Re: Approval of Exterior Building Materials for 1025 NE 1<sup>st</sup> Street

This is to advise you that, at a meeting of the McMinnville Historic Landmarks Committee (HLC) on Thursday, July 25, 2019, a revised built example for the exterior materials proposed for the new building at 1025 NE 1<sup>st</sup> Street was reviewed and carefully studied. The review of the built example was required as a condition of approval on the Downtown Design Review (DDR 1-19) application for the new apartment building. The subject property is located at 1025 NE 1<sup>st</sup> Street, and is more specifically described as Lots 5, 6, 7, and 8, Rowland's Addition. The subject site is also identified as Tax Lot 7900, Section 21BD, T. 4 S., R. 4 W., W.M.

For reference, a photo of the approved built example is provided below:

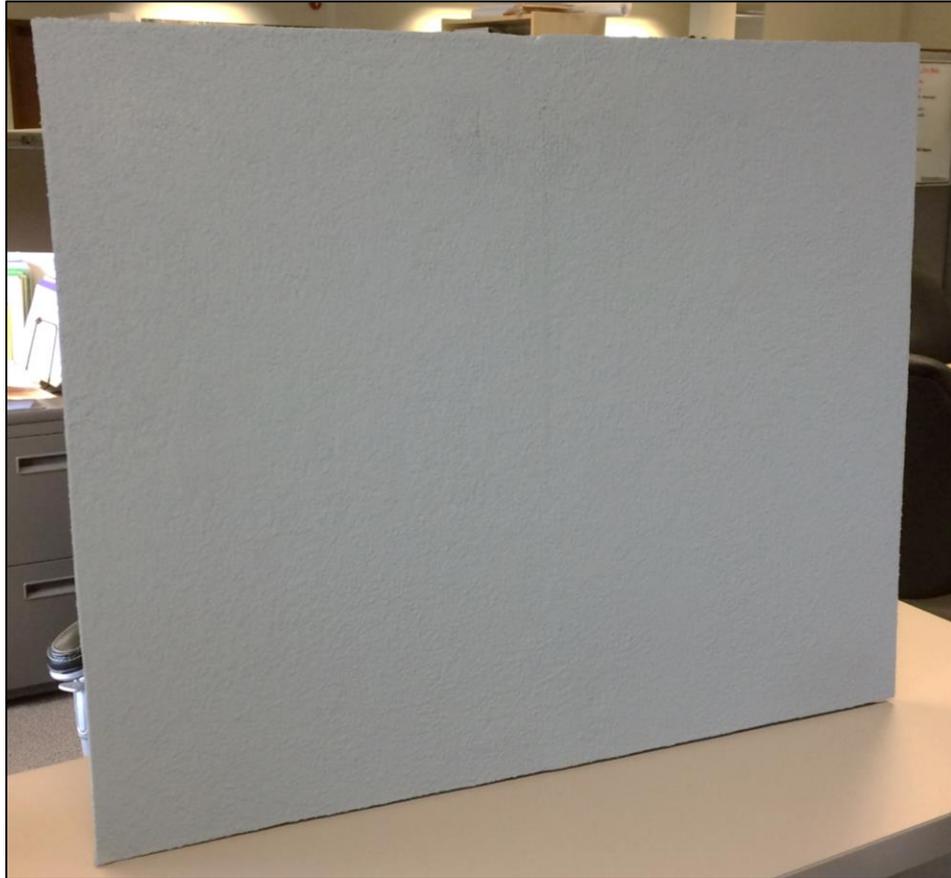
Based on the revised built example provided, the HLC voted to **APPROVE** the built example because it was found to be consistent with the applicable Downtown Design Standards in Section 17.59.050(C)(1) and the Findings of Fact in the DDR 1-19 Decision Document. More specifically, the HLC approved the built example that included the use of smooth Hardi panels that were finished with an exterior paint that included a sand additive to create a textured finish to the building material. The HLC approved this treatment for the main body of the building, but specified that the building trim, the center band between the first and second story, and the decorative cornice be smooth in appearance and not finished with exterior paint with the sand additive. The revised built example provided for review was found to be consistent with the applicable Downtown Design Standards in Section 17.59.050(C)(1) because the materials and treatment used were found to be similar in appearance to "smooth stucco" and similar in appearance to "building materials found on registered historic buildings in the downtown area". The vertical seam and reveal joint were also found to be less visible and better concealed.
